Clearwater Road/Golf Course Drive Bank Traffic Review

Baxter, Minnesota

BAXTE 191260 | June 3, 2026

Prepared for the City of Baxter

Figure 3 – Clearwater Road Adjustments

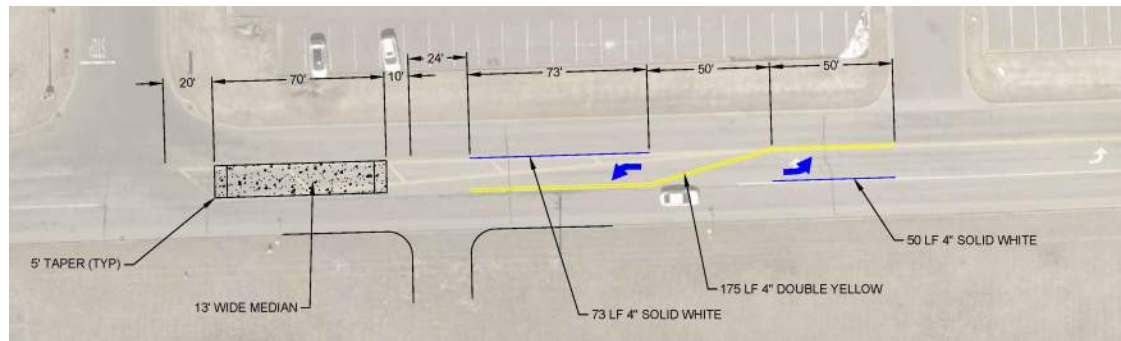
The proposed access locations on Clearwater Road and Golf Course Drive are not expected to meet turn lane warrants based on daily roadway and driveway volumes. However, it is recommended that Clearwater Road be restriped to include a short westbound left turn lane (50-100 feet) for the Clearwater Road access to make use of the existing striped median/turn lane space along Clearwater Road. To add the turn lane, the eastbound left turn lane and taper length at the intersection of Clearwater Road and Golf Course Drive will need to be shortened slightly, while still maintaining space for left turns into the Michaels access. A median should be added between the shared Target/Michaels access and the proposed bank access to prevent vehicles from using the median space to make a left turn into the Days Inn and Suites Driveway, which is located west of the shared Target/Michael access, presenting a safety issue for head-on left turning vehicles. **Figure 3** shows the recommended Clearwater Road adjustments; a full layout and vehicle turning movements are provided in **Appendix B**.

- Restripe Clearwater Road to include a short westbound left turn lane by shortening the eastbound left turn lane and taper length at the intersection of Clearwater Road and Golf Course Drive.
- A median should be added on Clearwater Road between the shared Target/Michaels access and the proposed bank access to prevent vehicles from using the median space to make a left turn into the Days Inn and Suites Driveway, which presents a safety issue for head-on left turning vehicles.
- **Figure 3** shows the recommended Clearwater Road adjustments; a full layout and vehicle turning movements are provided in **Appendix B**.

BELL BANK - BAXTER, MN

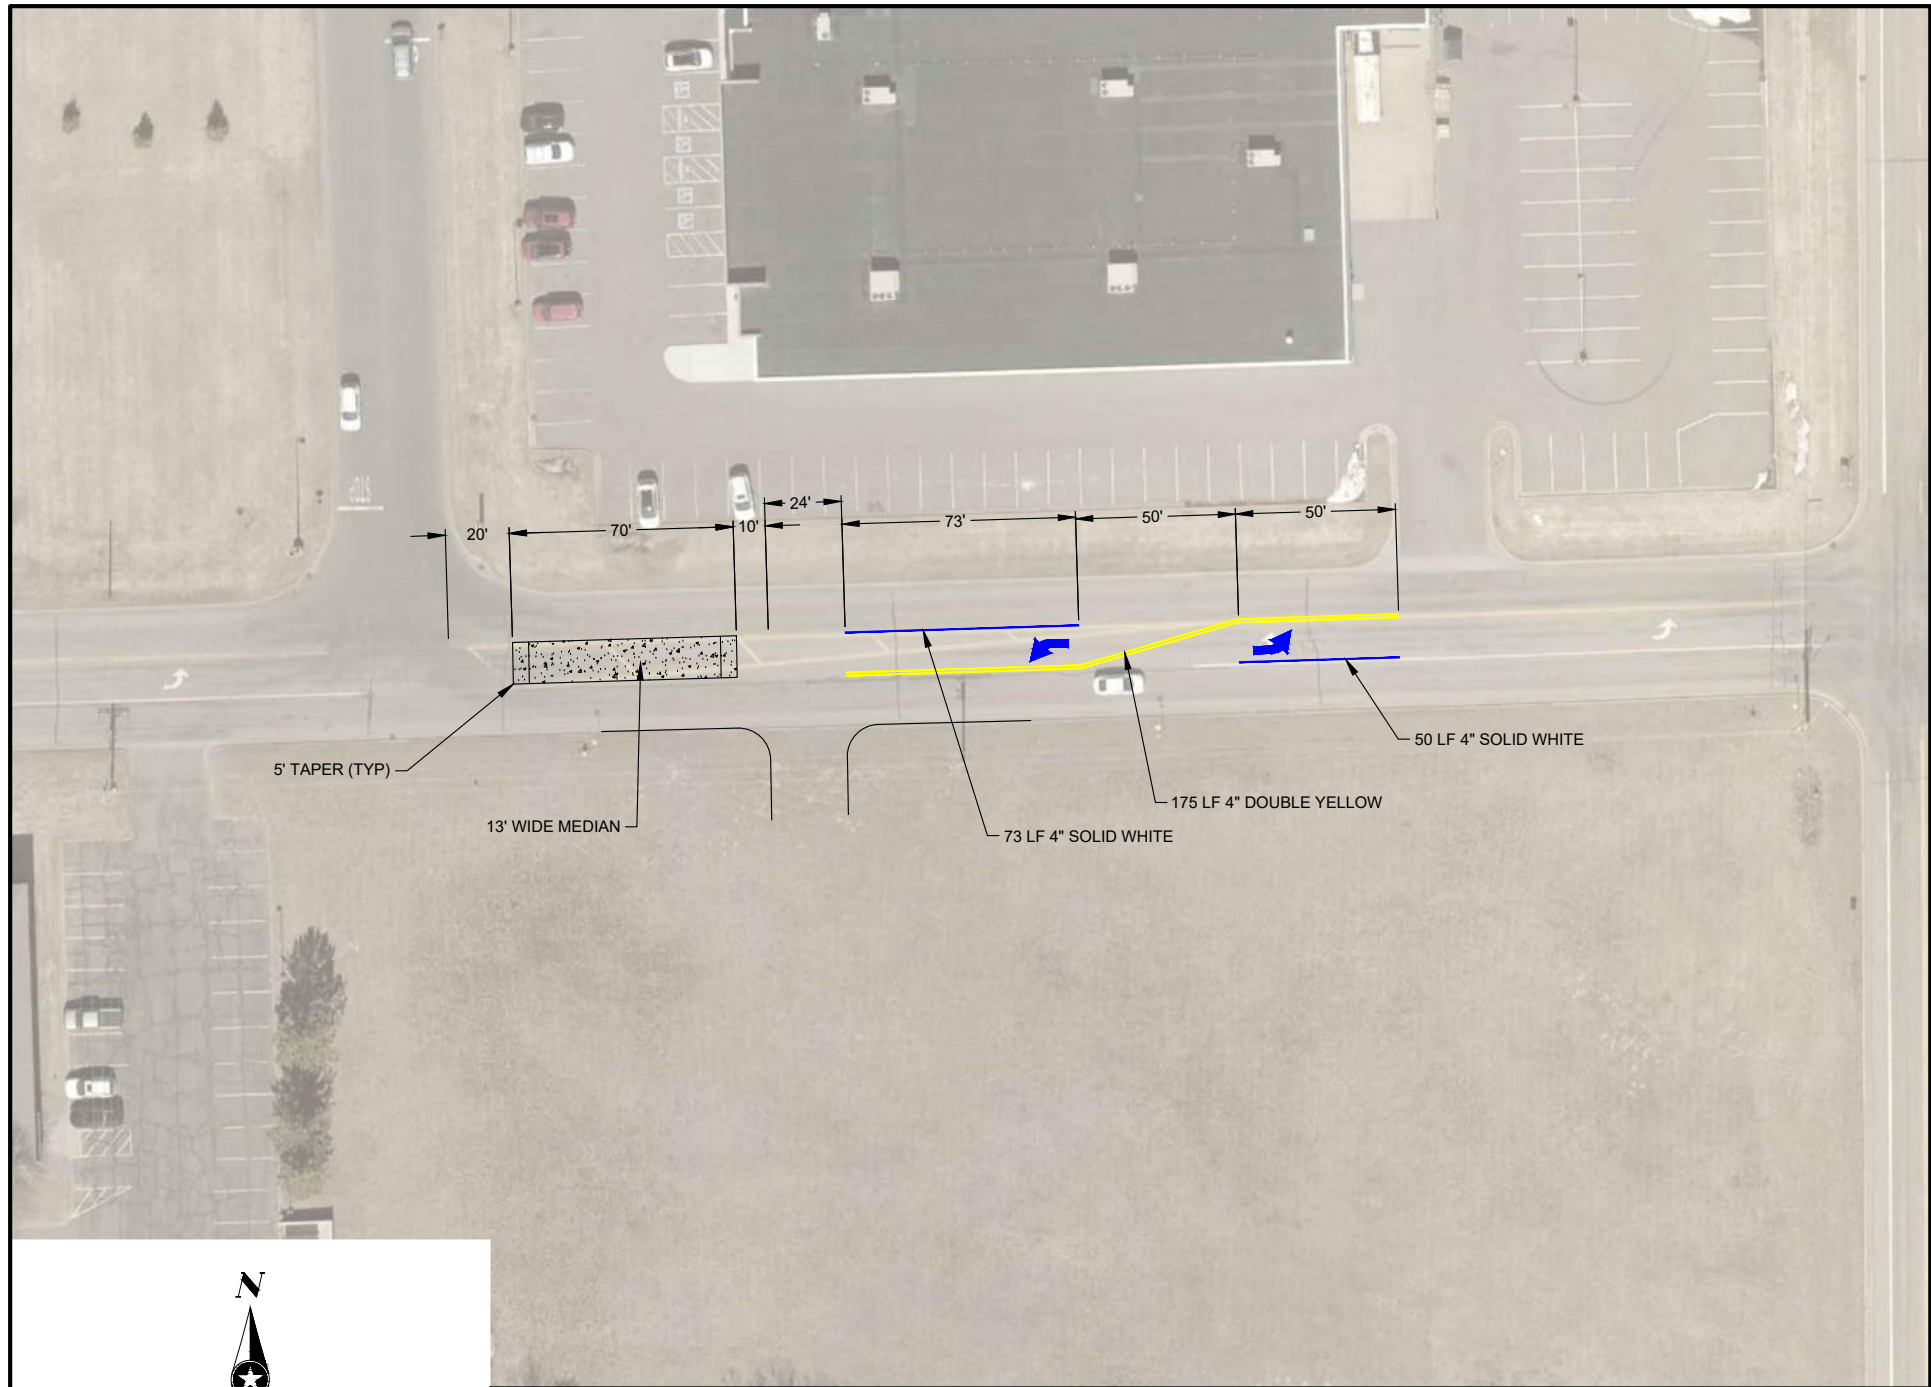
Along Clearwater Road, the proposed driveway access is located approximately 320 feet west of Golf Course Drive, approximately 175 feet west of the Michaels access, and approximately 100 feet east of the shared Target/Michaels access.

- The Clearwater Road access meets spacing guidelines, with at least 100 feet between each access. The spacing between the driveways provides enough space to stripe a short westbound left turn lane for vehicles entering the driveway.

Along Golf Course Drive, the proposed driveway access is located approximately 170 feet south of Clearwater Road, at the existing parcel lines on both the east and west side of the road.

- The proposed access does not fully meet access spacing guidelines as it is not 330 feet from Clearwater Road; However, the driveway lines up with the property lines on the east side of Golf Course Drive; the east side of Golf Course Drive should have a shared driveway in the future for the two parcels directly south of Clearwater Road.

Based on the high-level traffic review of the proposed bank with driveway through development in the southwest corner of the intersection of Clearwater Road and Golf Course Drive, the development is not expected to significantly impact the surrounding roadway network. The access locations as currently shown are acceptable, with the Clearwater Road access meeting the 100-foot spacing guidelines and the Golf Course Drive access lining up with the property lines
